# Staff Report

**To:** Salt Lake City Planning Commission  
**From:** Katilynn Harris, Principal Planner, [katilynn.harris@slcgov.com](mailto:katilynn.harris@slcgov.com), 801-535-6179  
**Date:** September 14, 2022  
**Re:** PLNPCM2022-00197, The Darlene

## Planned Development

**PROPERTY ADDRESS:** 906 S 200 W  
**PARCEL ID:** 15-12-258-033-0000  
**MASTER PLAN:** Downtown Master Plan  
**ZONING DISTRICT:** FB-UN2

**DARLENE APARTMENTS**  
SALT LAKE CITY, UTAH  
**SITE PLAN**

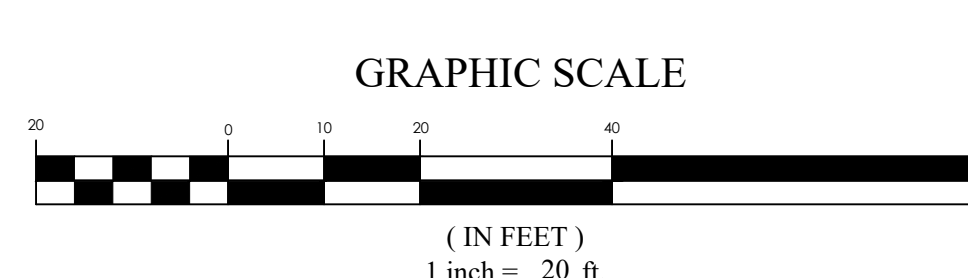
The façade length restriction allows for a break for not only aesthetics, form and compliance, but also allows for space for meters, vaults, services, etc. This should be considered in the request. The proposed plan shows the meter vault under curb and gutter which is not acceptable.

**Planning Staff Note:** The comment about the meter vault has been addressed by the applicant and the included site plan shows the revised location of the meter vault. Final approval from public utilities will be required at the building permit stage.

DRAWING NUMBER  
**A-01**  
PROJECT NUMBER  
Project Number  
ISSUE DATE:  
PD SUBMITTAL

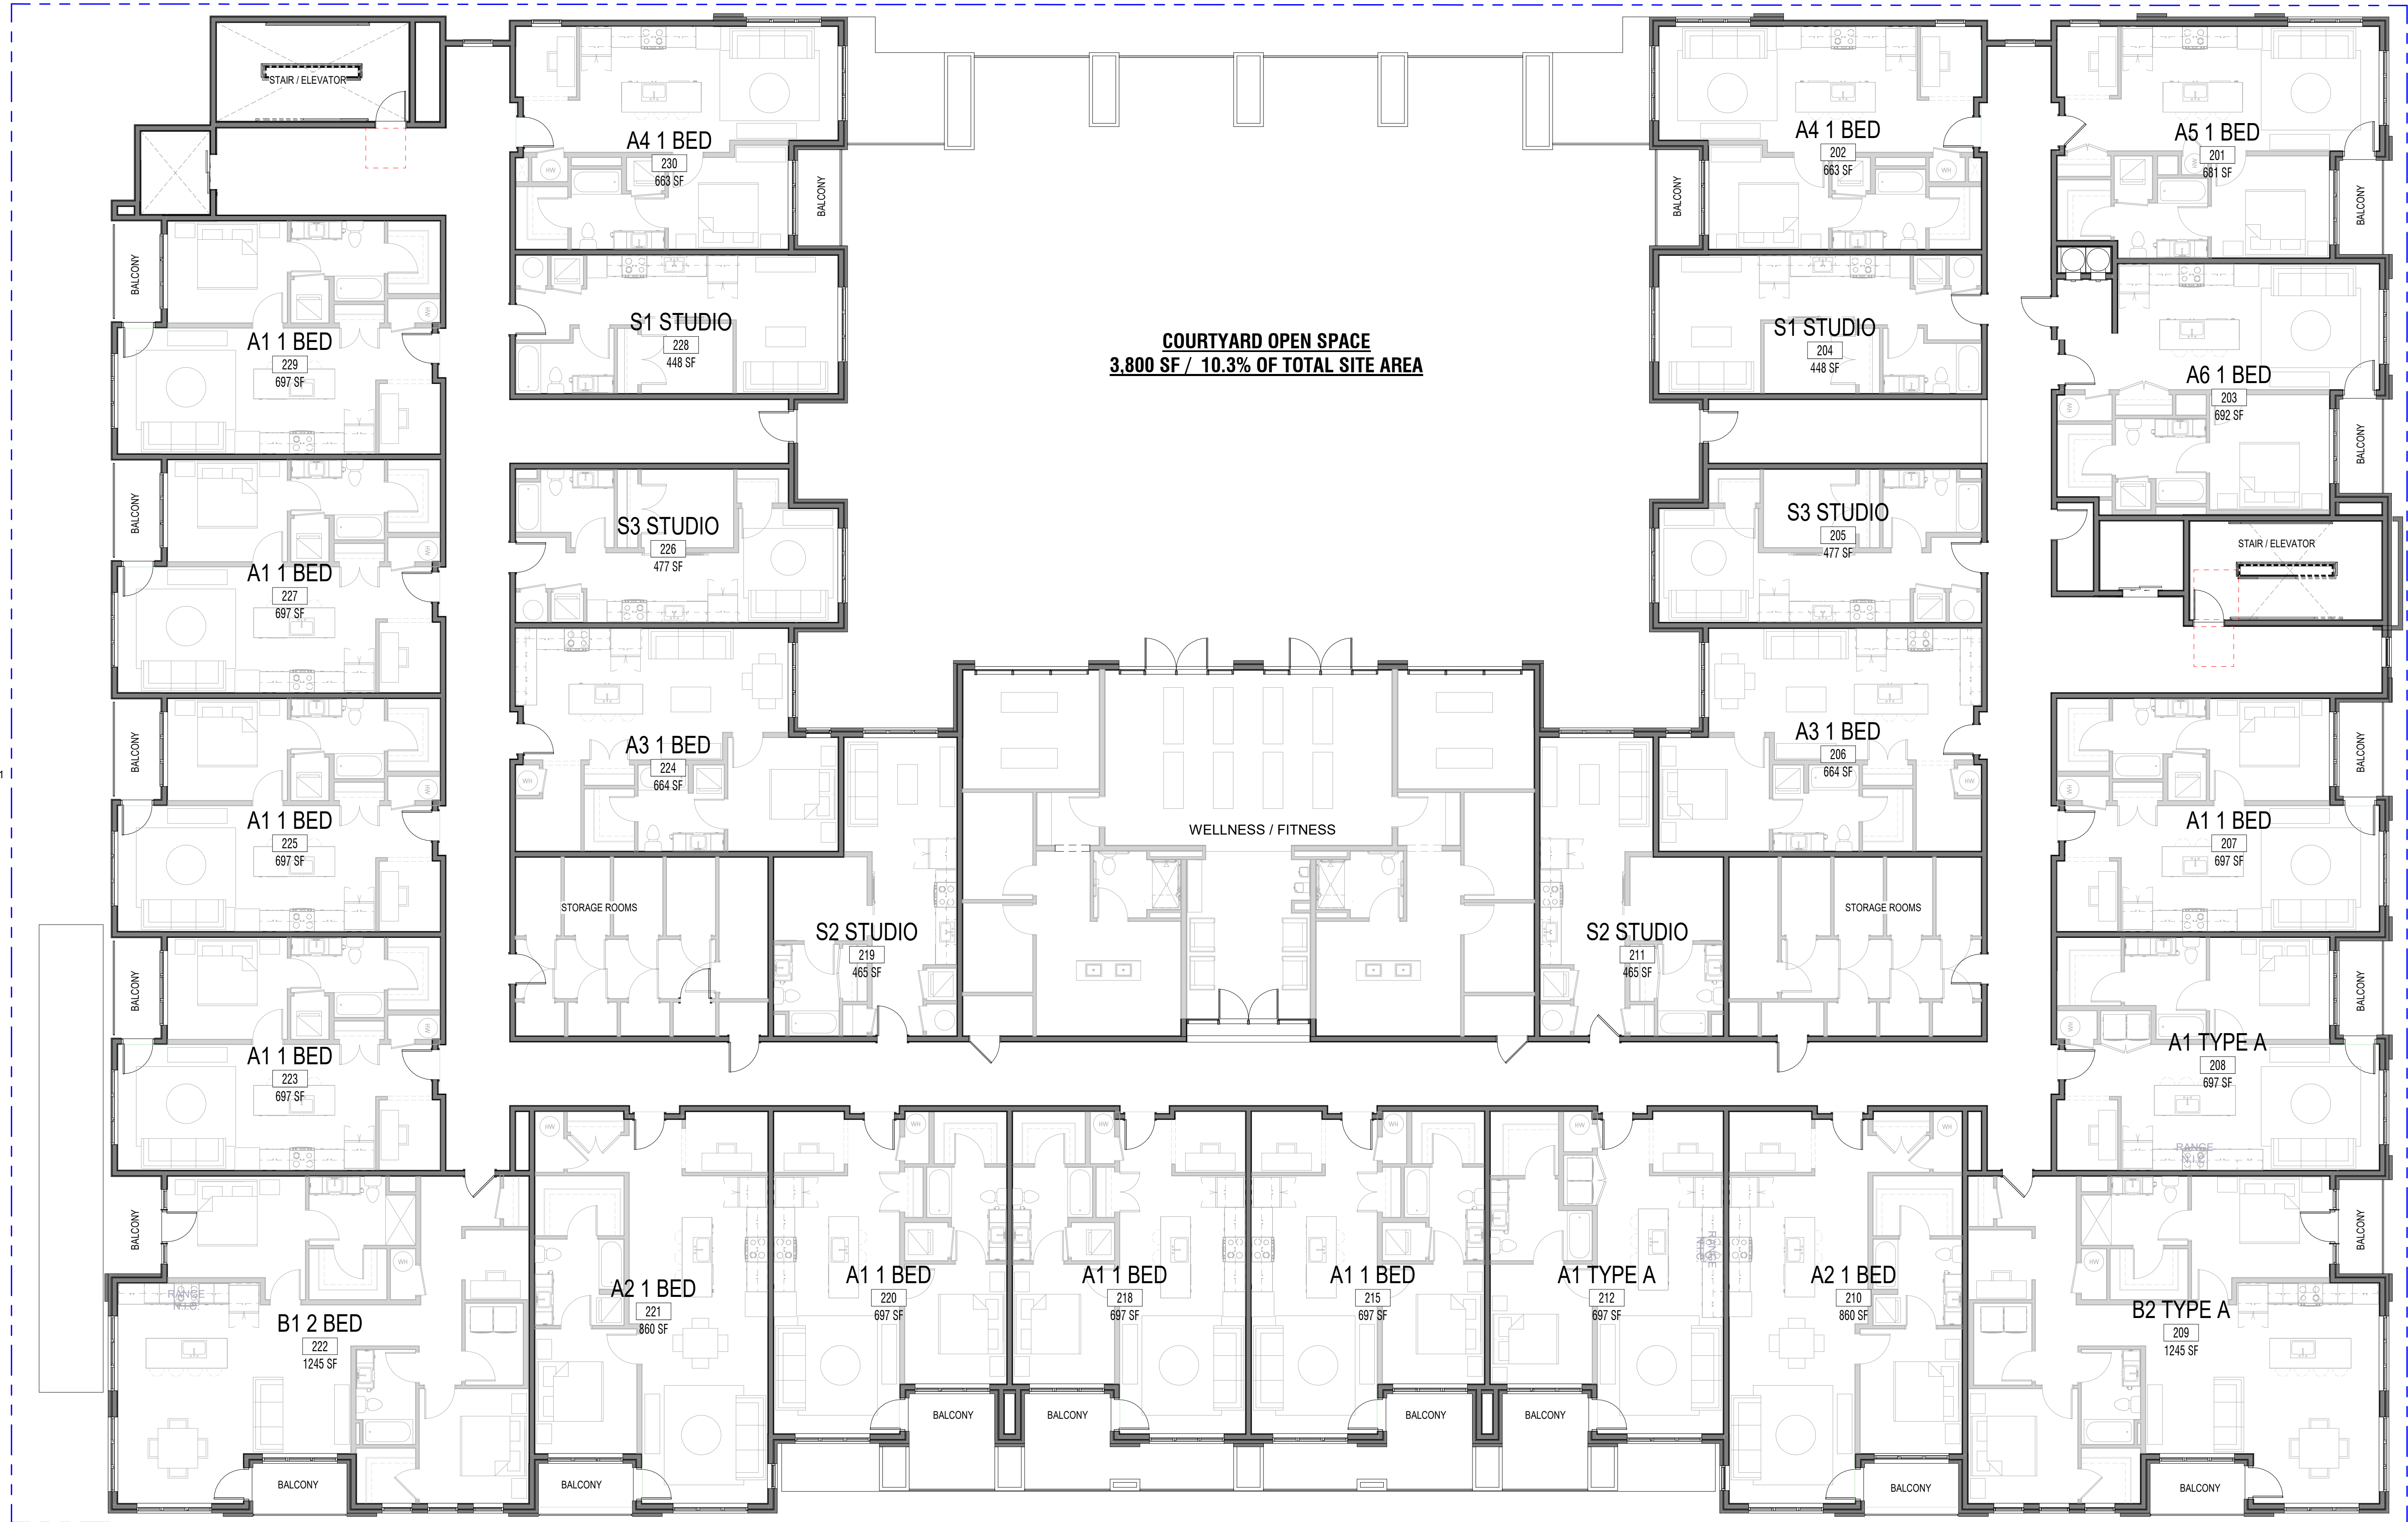
Complete for Planning process. Note, however, that an issue may arise during building code review at time of permit application. Per IBC 1028.1, the exterior exit door shall be readily visible and identifiable from the point of termination of the interior exit stairway enclosure. This is not obvious on plan sheet A-01.

Figure #1

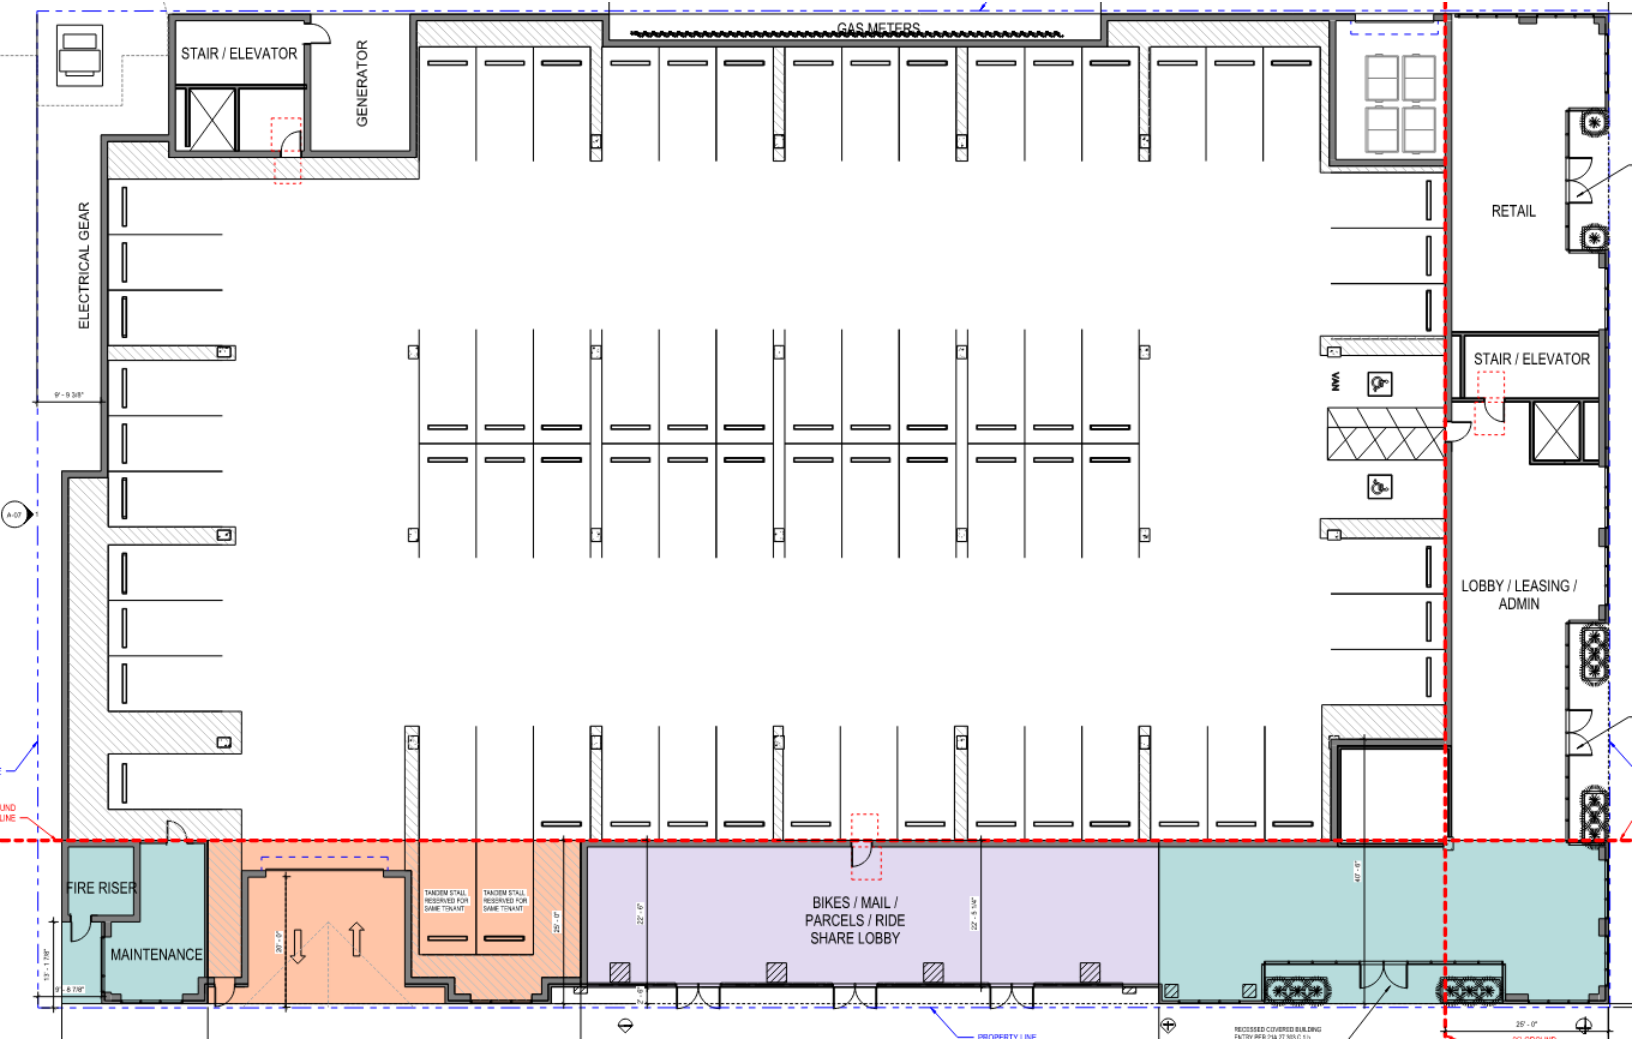
***Along the façade of 200W, 75.88% of the façade length will consist of a permitted use which is past the threshold of 75% for a permitted use per the zoning requirements. Of the 75.88%, 38.5% of that façade length has a permitted use that extends 25' into the structure as required. However, 37.38% of the façade length has a permitted use that extends 22' - 6" into the structure. CW is requesting a variance for the 37.38% of the façade being 2' – 6" short of the 25-foot extension requirement. The purpose of the 2' – 6" recession is to break up the massing of the façade to create greater visual interest along a façade that is greater than 200 ft. (See Figure 1 for reference)***
